SUBJECT: ISSUANCE OF AMENDMENT FOR CALVERT CLIFFS NUCLEAR POWER PLANT
UNIT 2 (TAC NO. 77840)

This amendment replaces the existing 0-10 effective full power years (EFPY) and 10-40 EFPY heatup and cooldown curves with 0-12 EFPY heatup and cooldown curves. These curves are based on the final version of Regulatory Guide 1.99, Revision 2, and use Combustion Engineering methodology, which has been previously reviewed and approved. These new calculations also resulted in Technical Specification changes to the low temperature overpressure protection (LTOP) system; including the pressure operated relief valves (PORV) lift setpoint, the reactor coolant pump (RCP) controls, the high pressure safety injection (HPSI) operability and the HPSI controls which are reflected in this amendment. The supporting TS Bases were modified to reflect the changes.

Amendment No. 131
License No. DPR-69

ATTACHMENT TO LICENSE AMENDMENTS

FIGURE 3.4-2b
CALVERT CLIFFS UNIT 2 HEATUP CURVE, 12 EFPPY
REACTOR COOLANT SYSTEM PRESSURE TEMPERATURE LIMITS

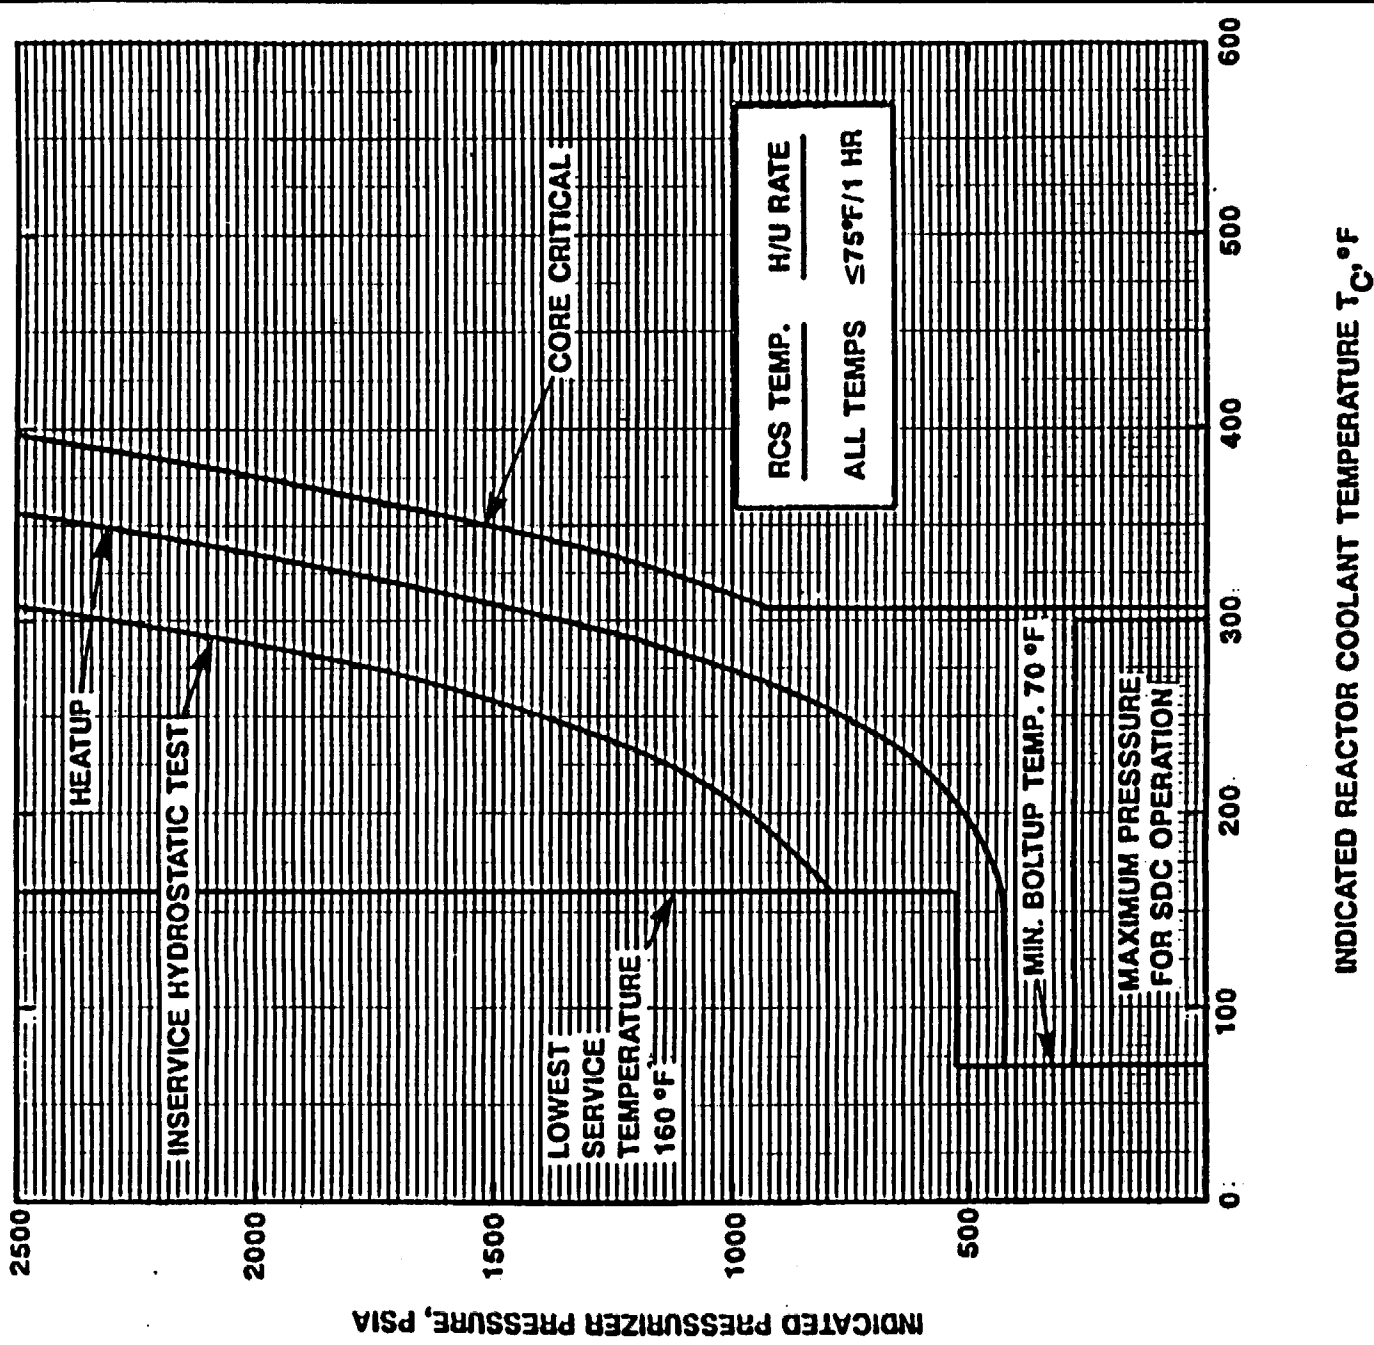
Similarly, 10 CFR Part 50 specifies that core critical limits be established based on material considerations. This limit is shown on the heatup curve, Figure 3.4-2b. Note that this limit does not consider the core reactivity safety analyses that actually control the temperature at which the core can be brought critical.

3.4.9.1 The Reactor Coolant System (except the pressurizer) temperature and pressure shall be limited in accordance with the limit lines shown on Figure 3.4-2 during heatup, cooldown, criticality, and inservice leak and hydrostatic testing with:
